This service bulletin complements Service Handbook Group 37 88917352 and 88917383

FL, FE

CHID B564590-

## Wiring diagram, changed fuses

WIRING DIAGRAM GF

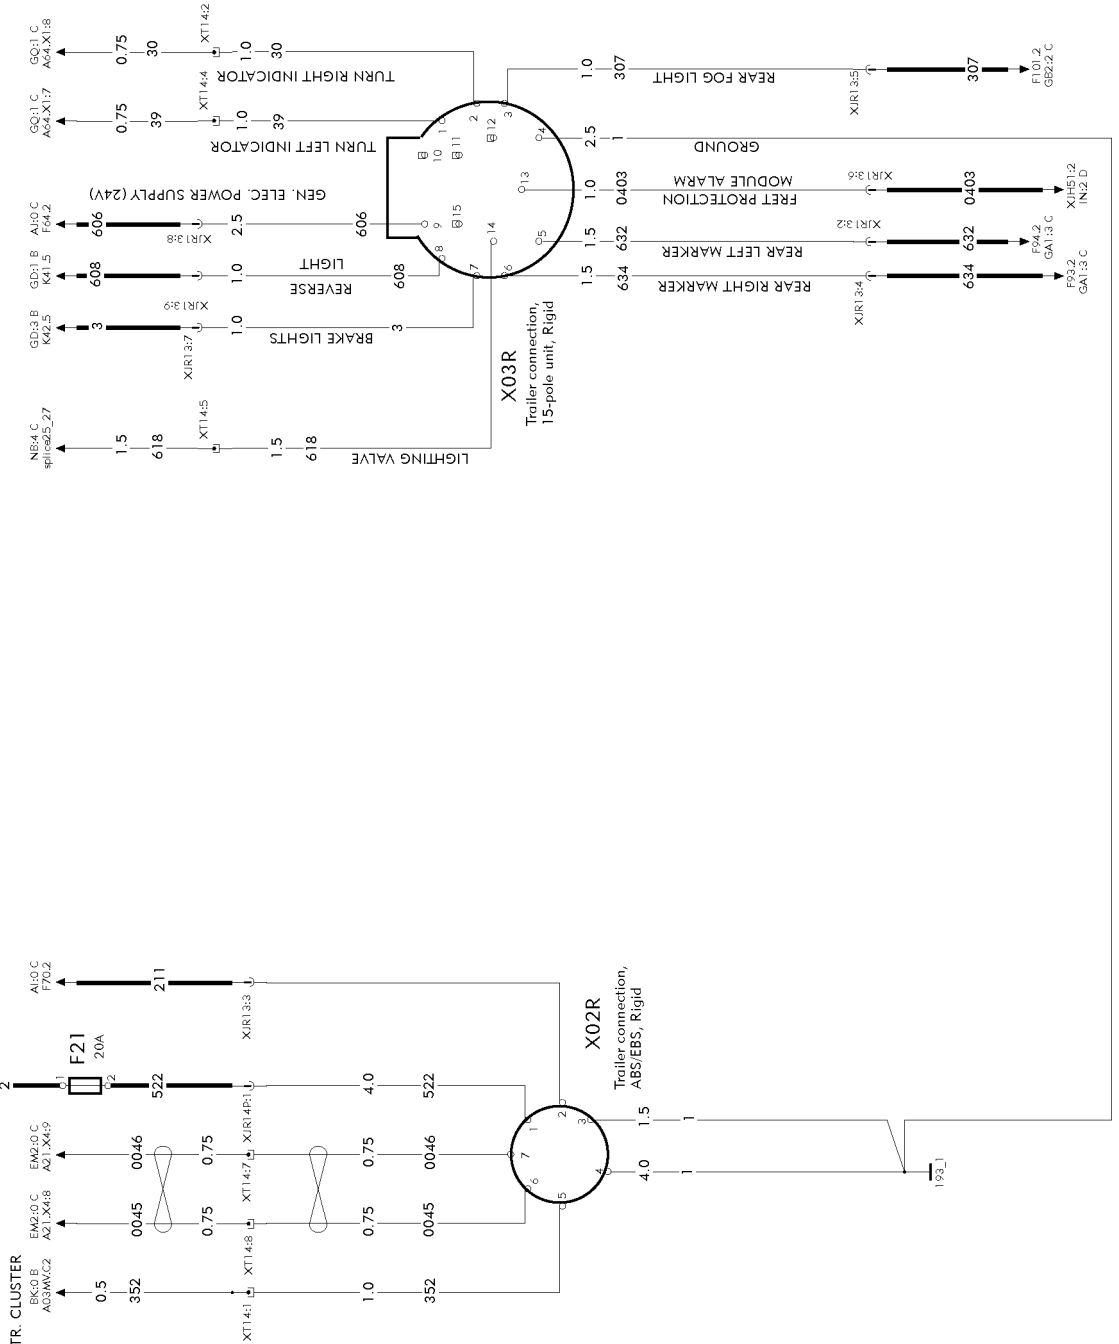
F93, parking lighting trailer/body builder connector 10A fuse is replaced by 15A fuse (pos.52).

F94, parking lighting trailer/body builder connector 10A fuse is replaced by 15A fuse (pos.53).

WIRING DIAGRAM HY

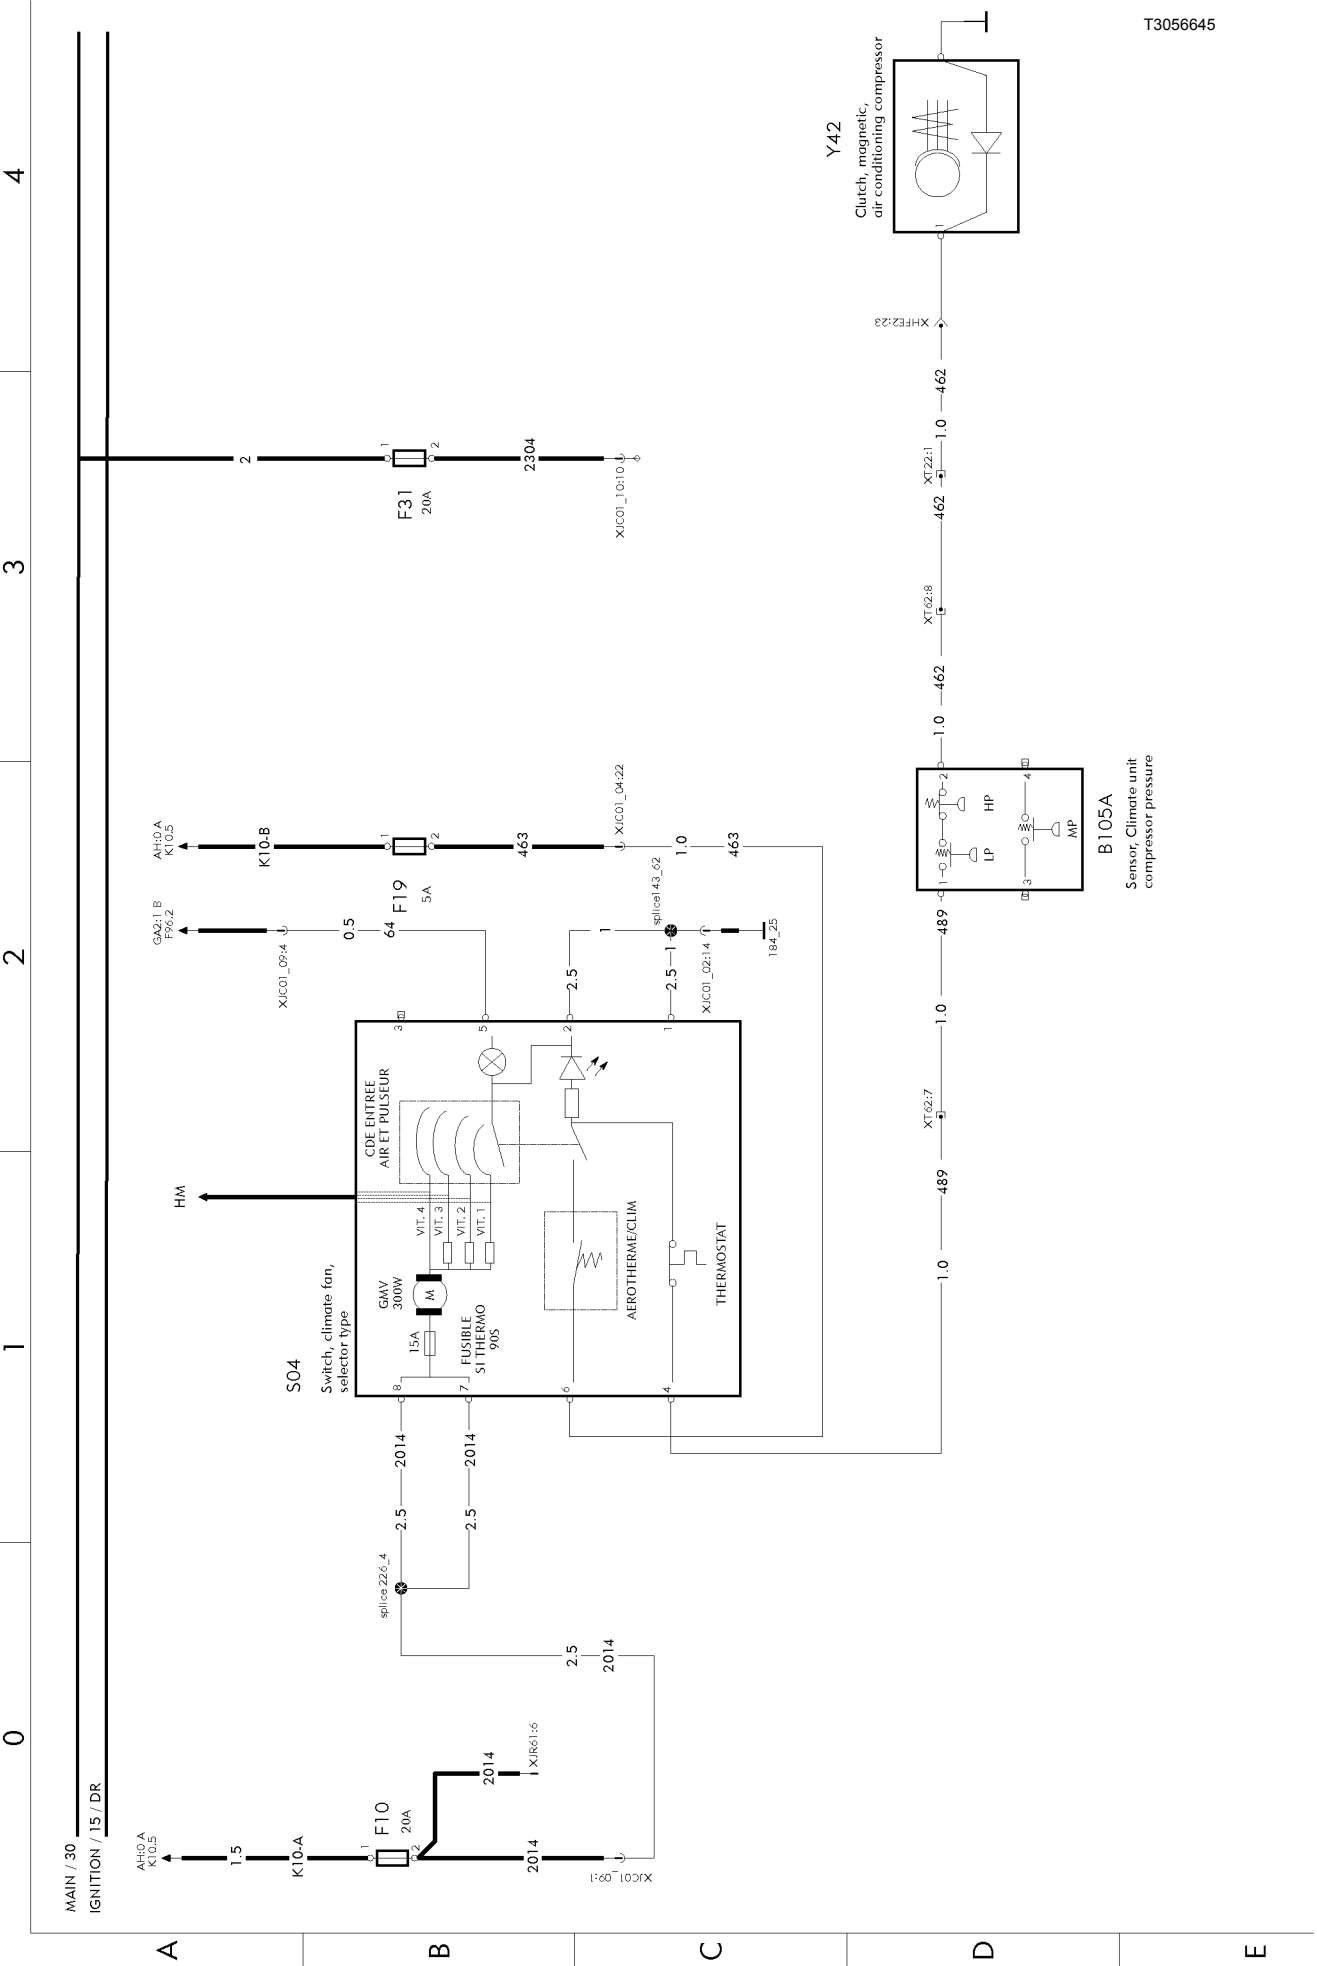
F10, climate unit, 15A fuse is replaced by 20A fuse (pos.76).

## EJB FL

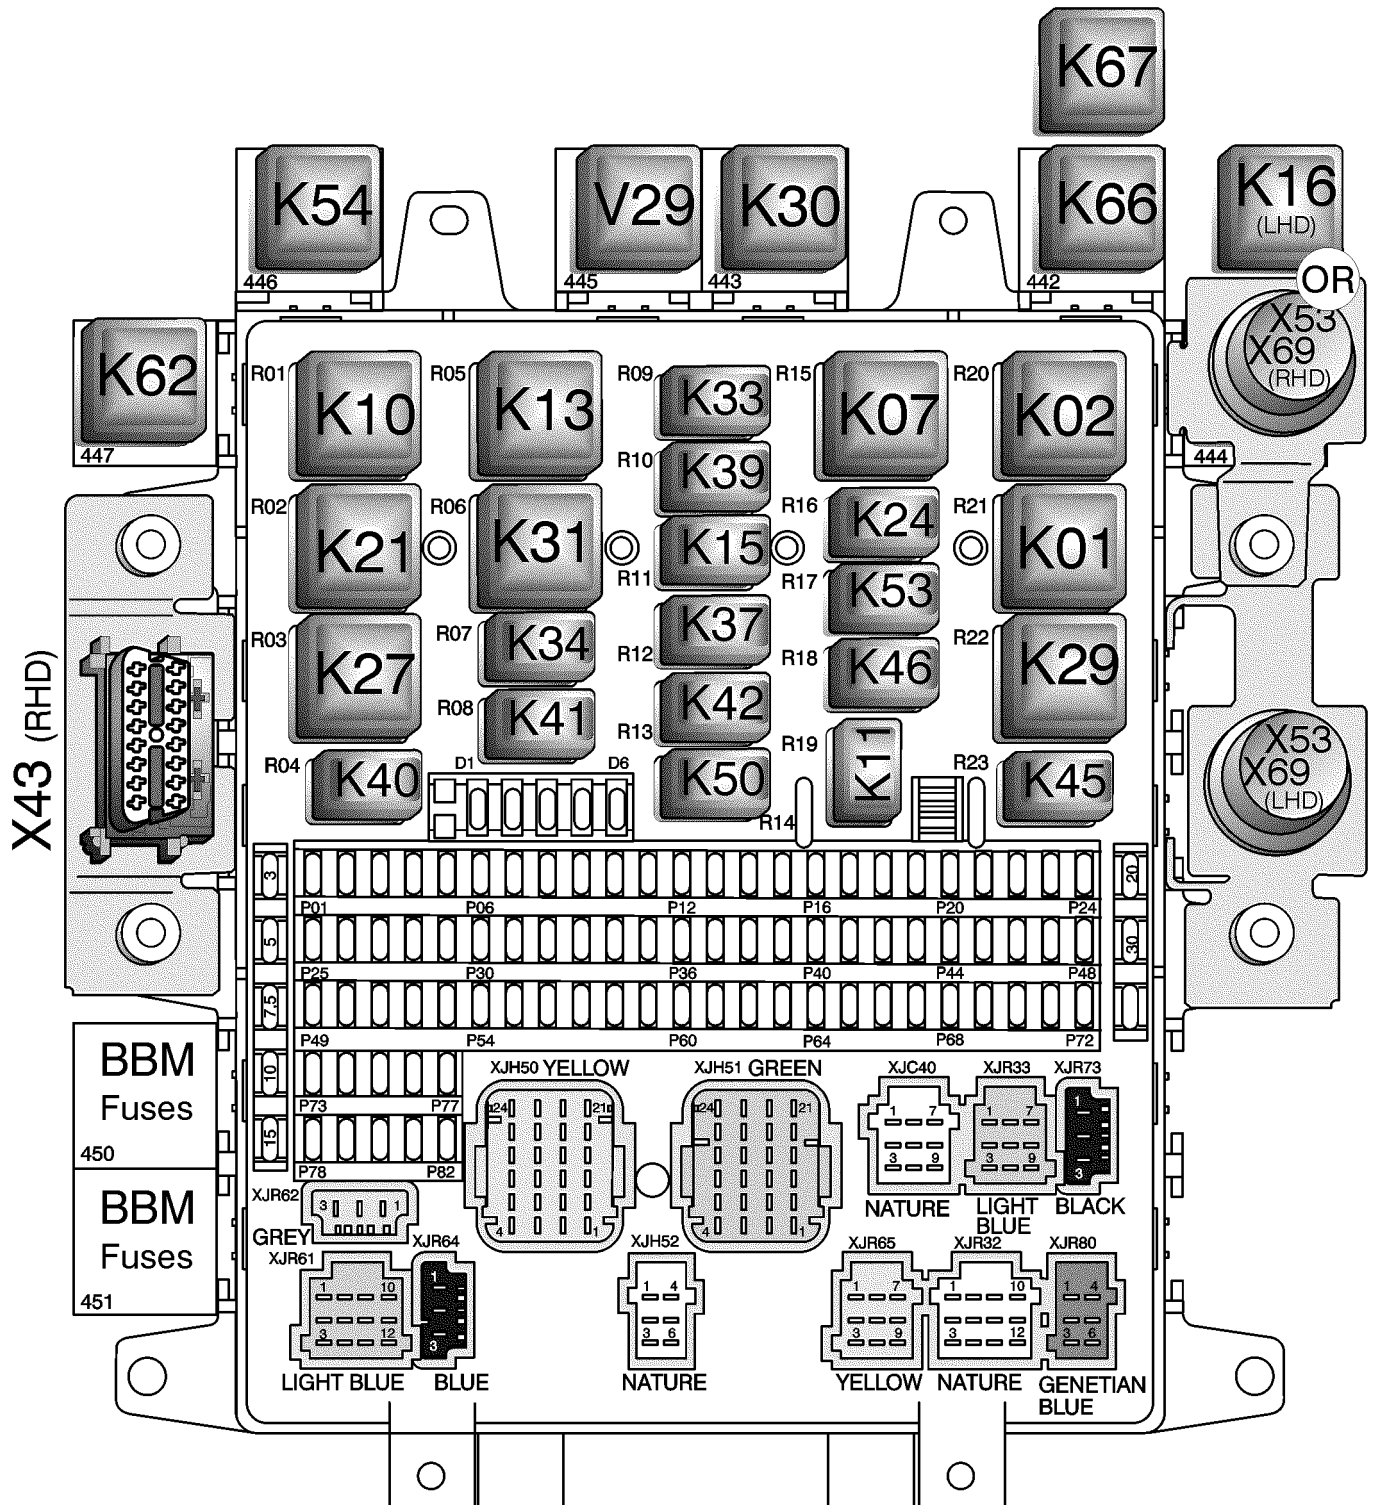
### Changed fuses

WIRING DIAGRAM HY

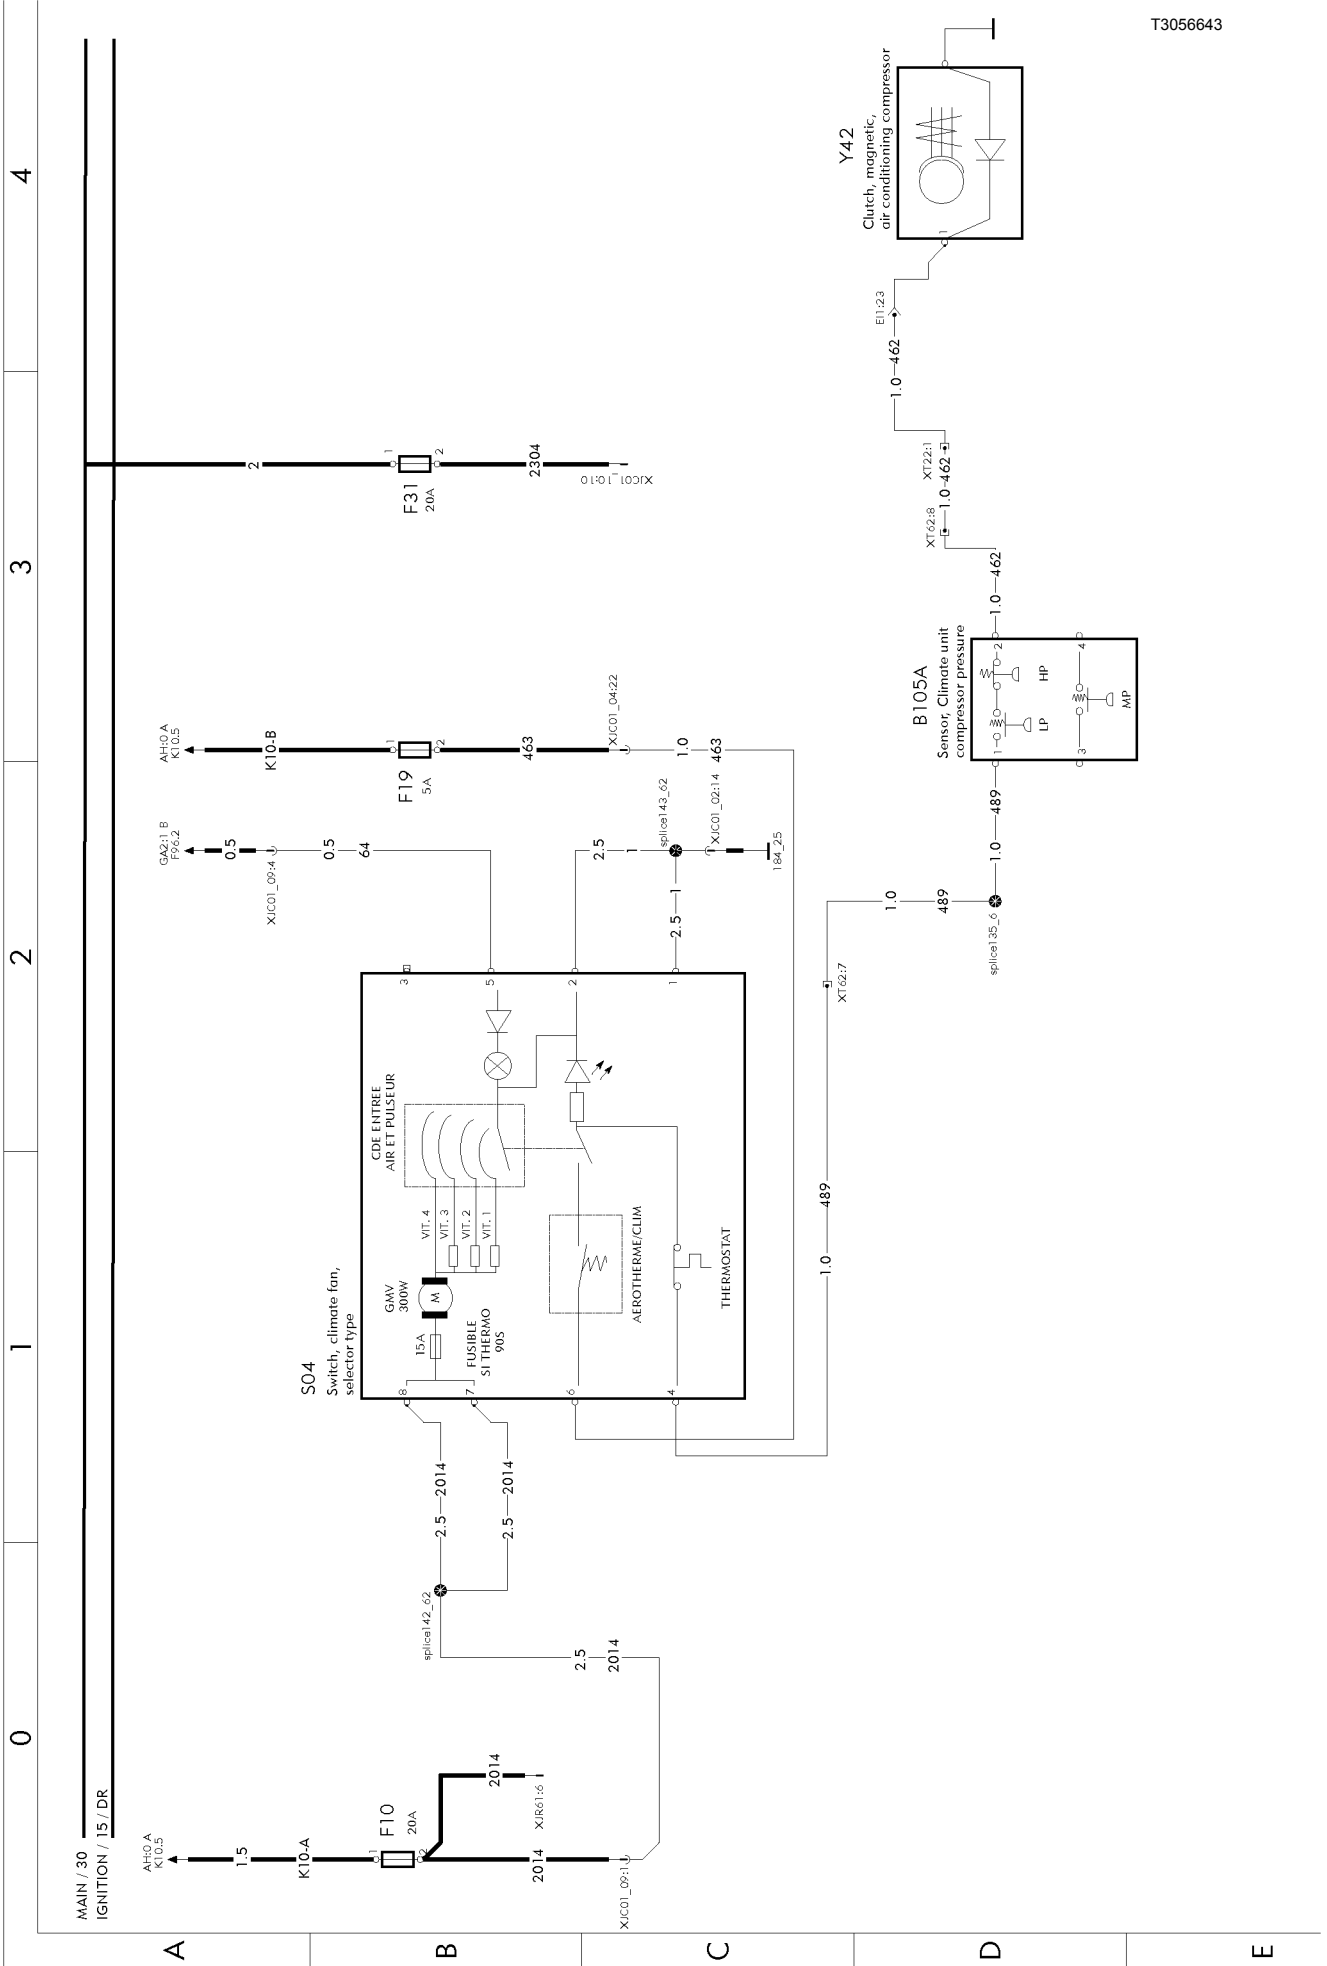
F10, climate unit, 15A fuse is replaced by 20A fuse (pos.76).

## EJB FE

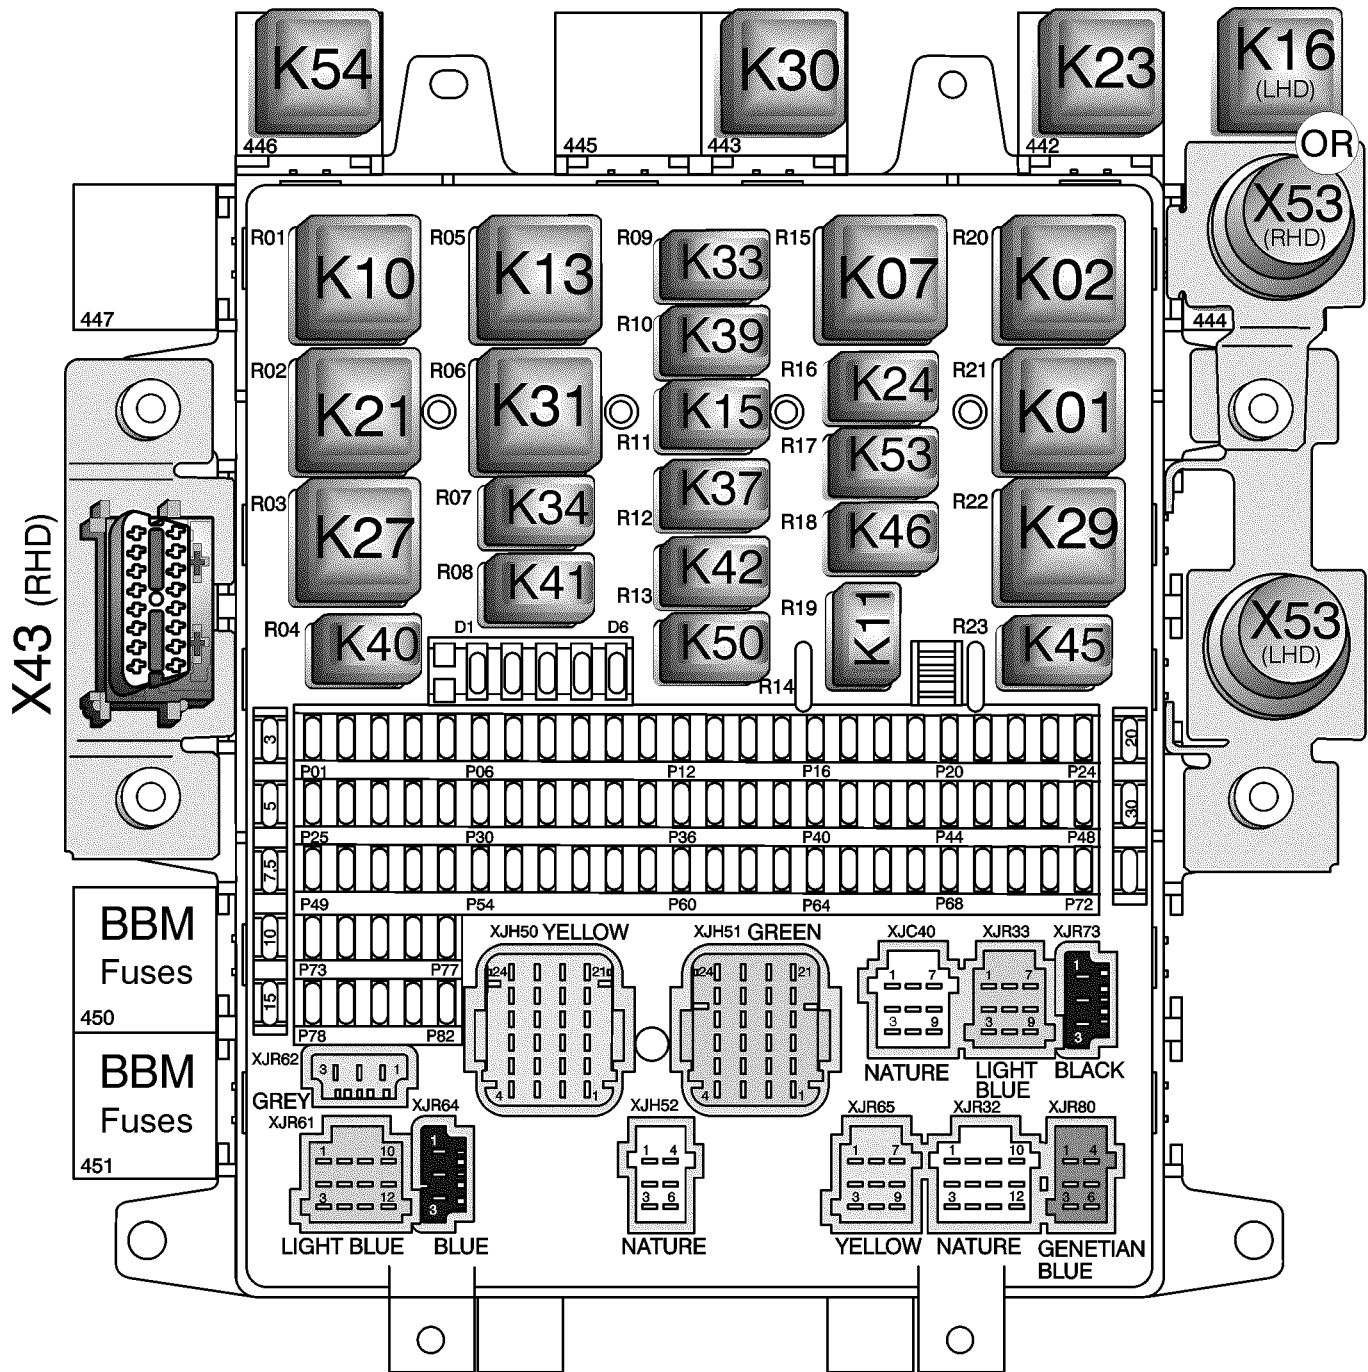
### Changed fuses

F93, parking lighting trailer/body builder connector 10A fuse is replaced by 15A fuse (pos.52).

F94, parking lighting trailer/body builder connector 10A fuse is replaced by 15A fuse (pos.53).
